**RE: Colowyo Coal Company L.P.
 Permit No. C-1981-019
 Technical Revision No. 140
 East Taylor Seep French Drain**

Revision Description: **TR-140 East Taylor Seep
French Drain**

Figure 4.05.7-1
East Taylor Seep French Drain

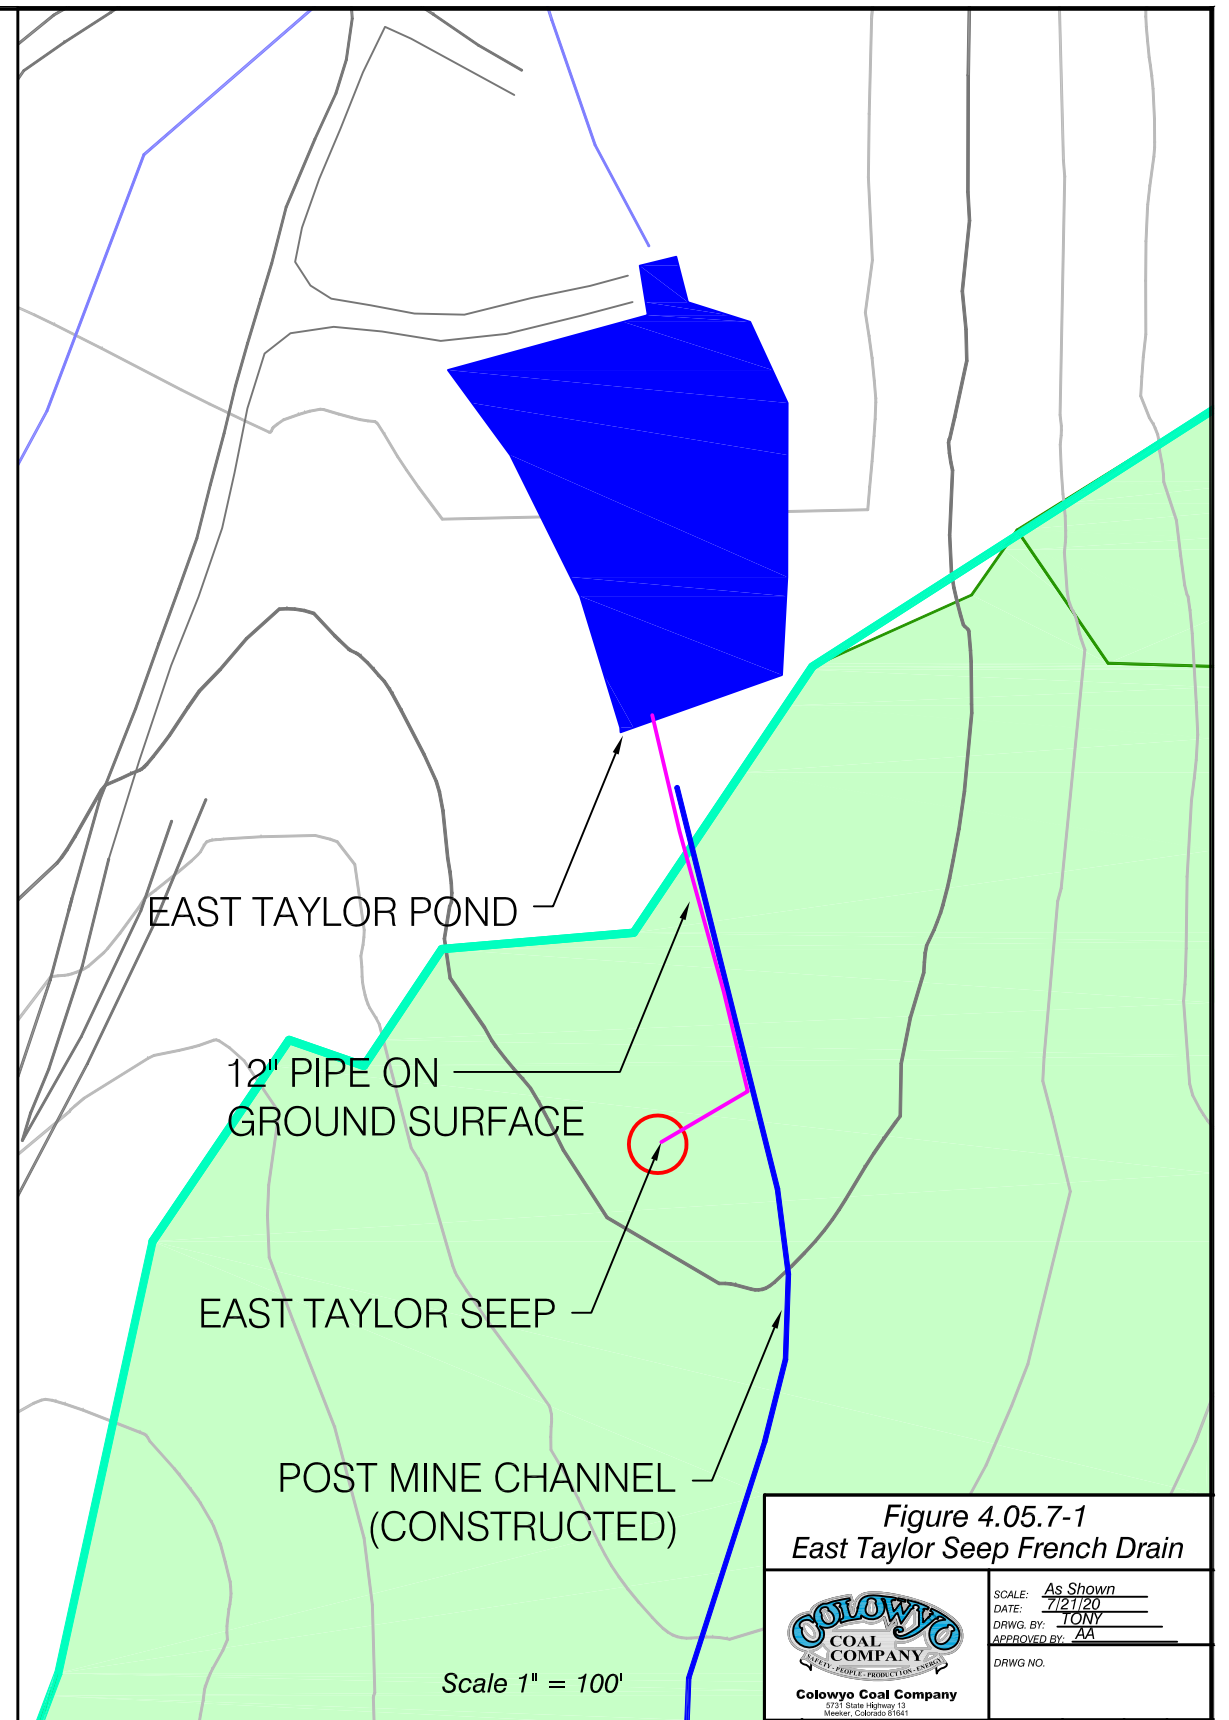
It was deemed necessary to install a french drain structure to monitor the flows from the East Taylor Seep. The East Taylor Seep is just above (south) of the East Taylor Pond. A clean washed gravel filter was installed to route water to an underground-perforated pipe. The perforated pipe

then routes from the seep water to the surface to a parshall flume for flow measurements. At the outlet of the parshall flume, the water is then routed through another twelve-inch solid pipe, which is on the ground surface directly adjacent (west) to the Taylor Trib Ditch. The pipe ends at the inlet of the East Taylor Pond where the seep water is discharged into the East Taylor Pond. The location and a design for this french drain system is presented on Figure 4.05.7-1.
